RENESAS TECHNICAL UPDATE

Product Category	MPU & MCU		Document No.	TN-16C-A237A/E	Rev.	1.00
Title	Deletion of Specifications and Errata for R32C/111 Group User's Manual: Hardware		Information Category	Technical Notification		
Applicable Product	R32C/111 Group	Lot No.	Reference Document	R32C/111 Group User's Manual: Hardware Rev. 1.20 (R01UH0209EJ0120)

This document describes deletion of specifications and errata for the R32C/111 Group User's Manual: Hardware, Rev. 1.20.

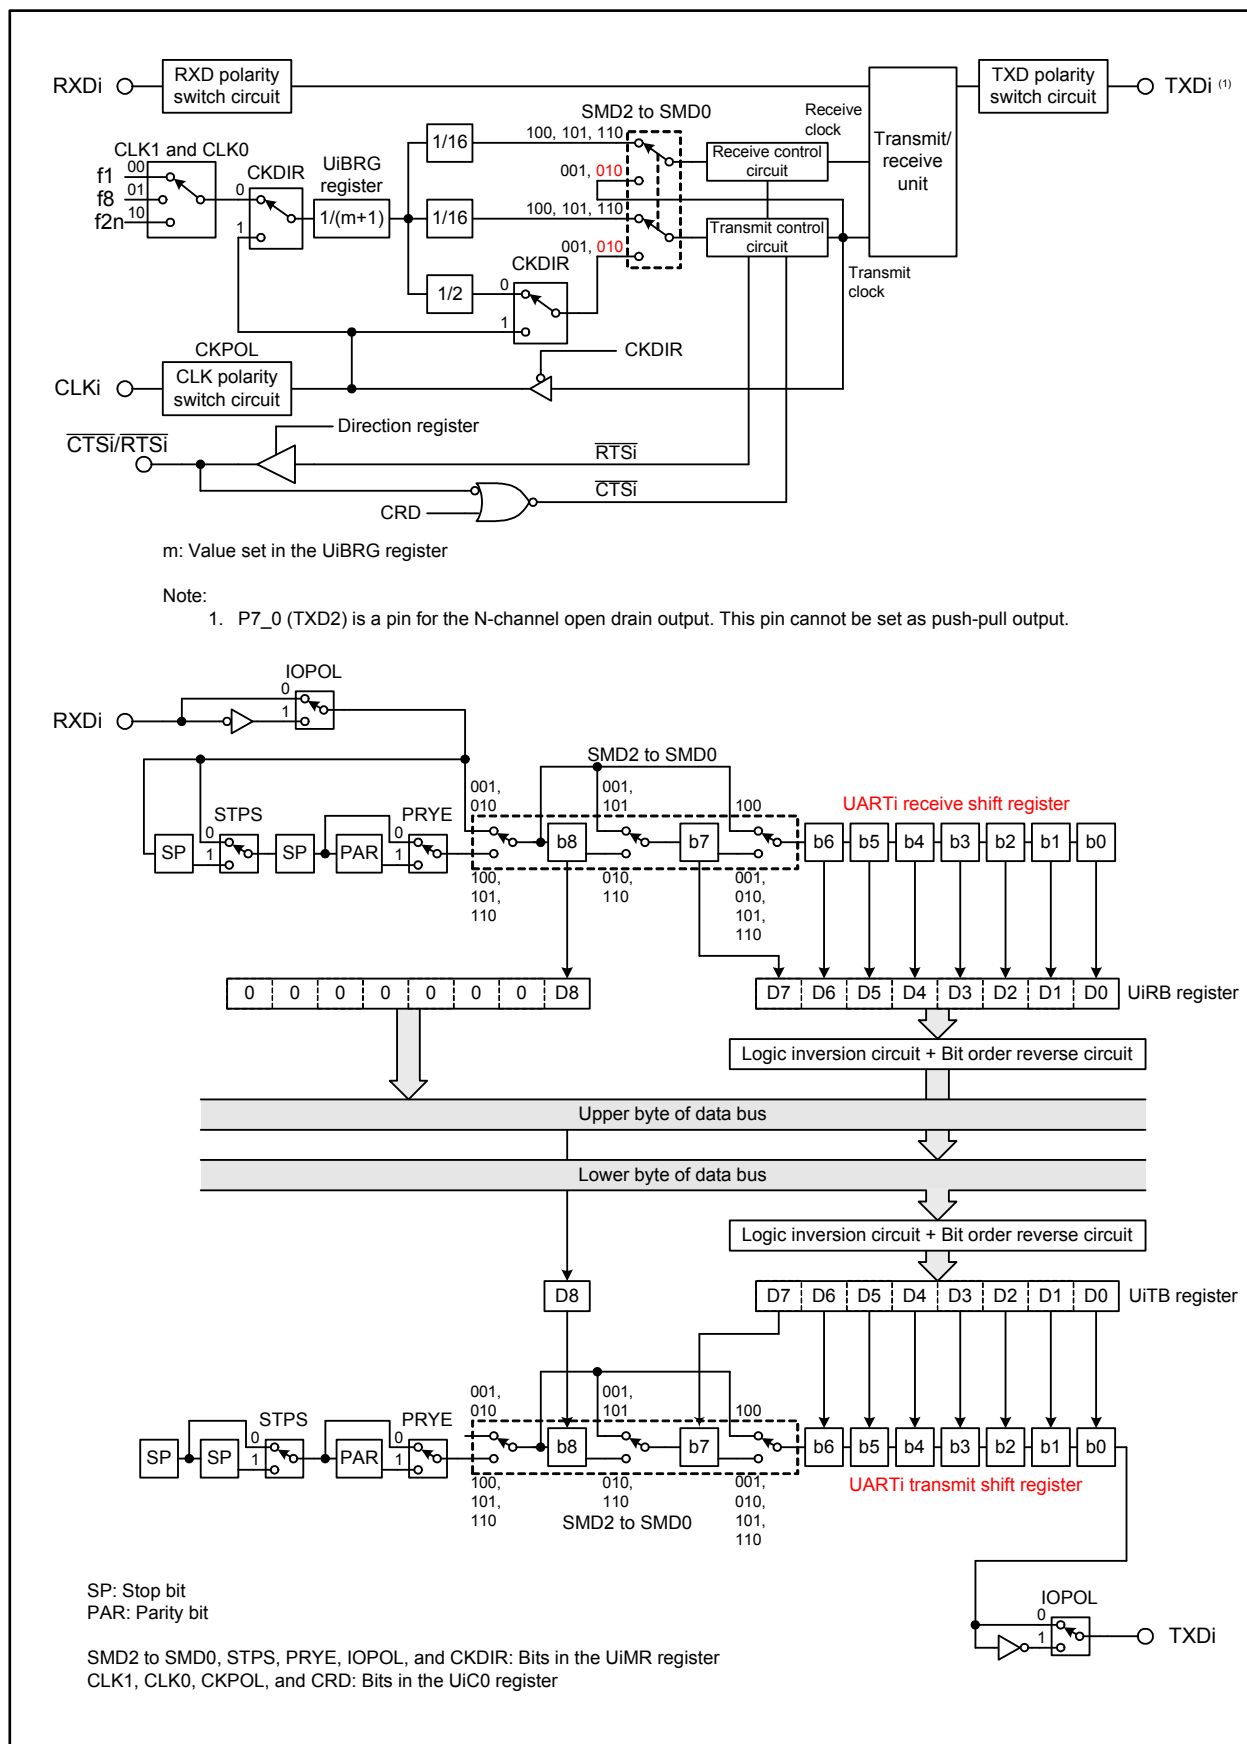
•Page 240 of 493, positions of “010” for bits SMD2 to SMD0 in Figure 18.1 are corrected as follows:

Transmit timing (when selecting an internal clock)

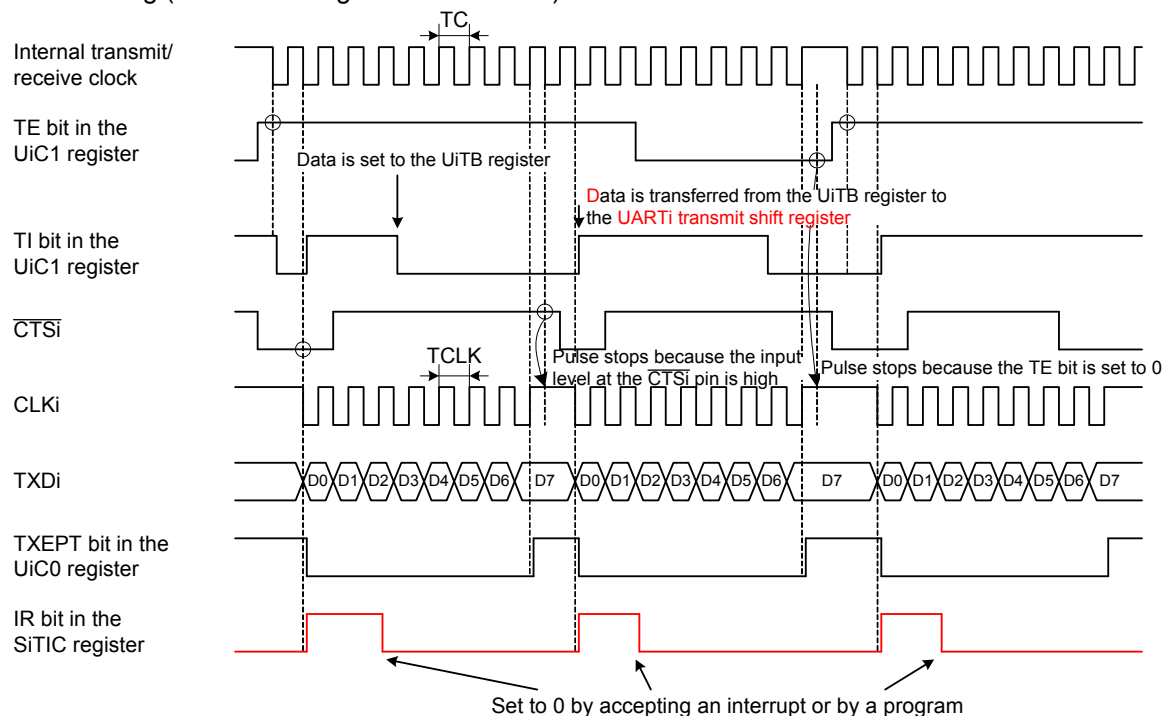
- Page 246 of 493, description in Function of the UIIRS bit in Figure 18.7 is modified as follows:
“0: **Transmit buffer** is empty (TI = 1)”
- Page 250 of 493, expression “baud rate generator count source” in the function of bits DL0 to DL2 in Figure 18.12 is corrected as follows:
“**count source for the UiBRG register**”
- Pages 257, 258, 265, 266, 275, 285 of 493, descriptions in Function of the UiBRG register in Tables 18.3, 18.4, 18.6, 18.7, 18.10, and 18.15 are modified as follows:
“**Set the divide ratio according to the bit rate**”
- Pages 258, 266 of 493, description for (b7 to b4) to registers UiC1 and U78CON in Tables 18.4 and 18.7 is added as follows:
“(b7 to b4) **Set the bits to 0000b**”
- Page 259 of 493, waveform of the IR bit in Figure 18.20 is corrected as follows:

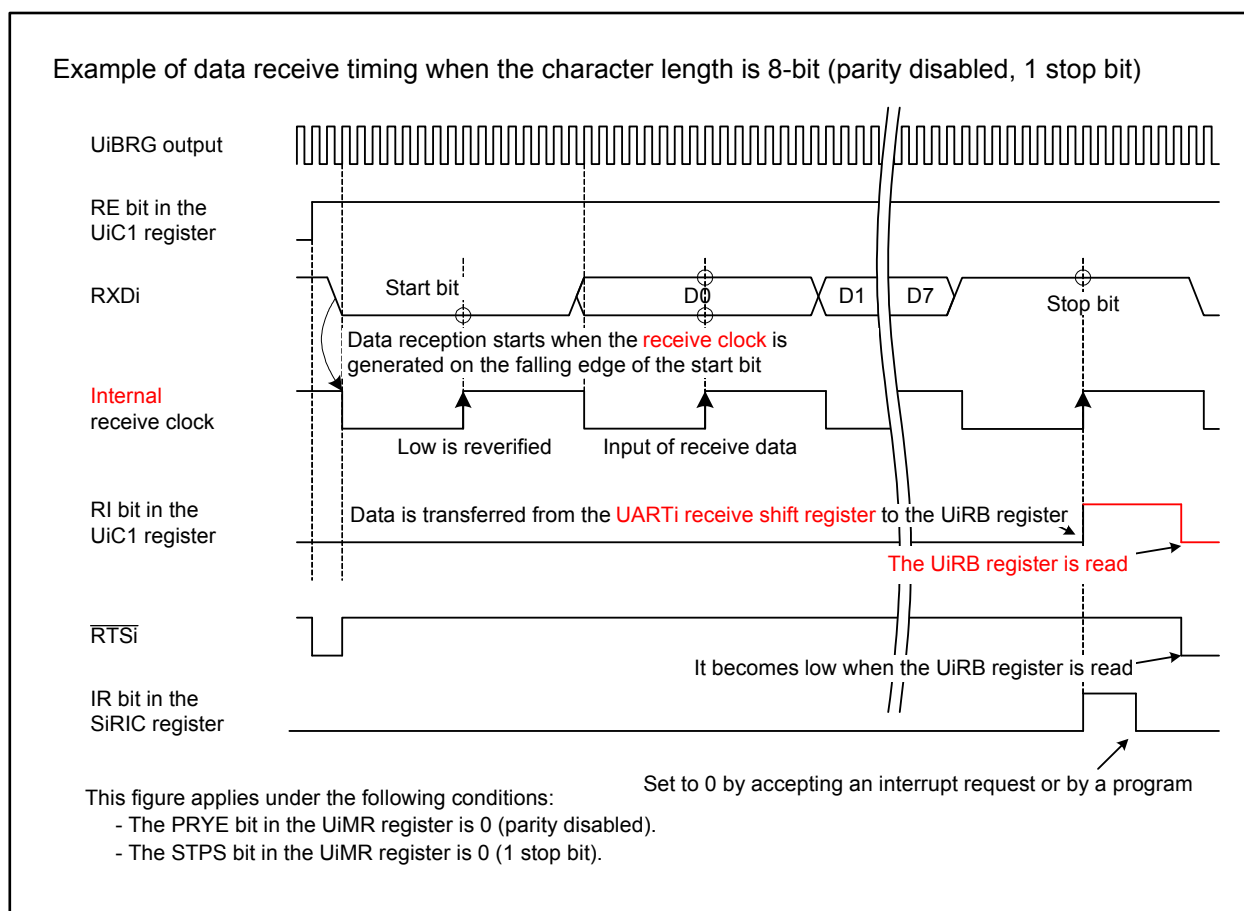
- Page 269 of 493, Figure 18.27 is corrected as follows:
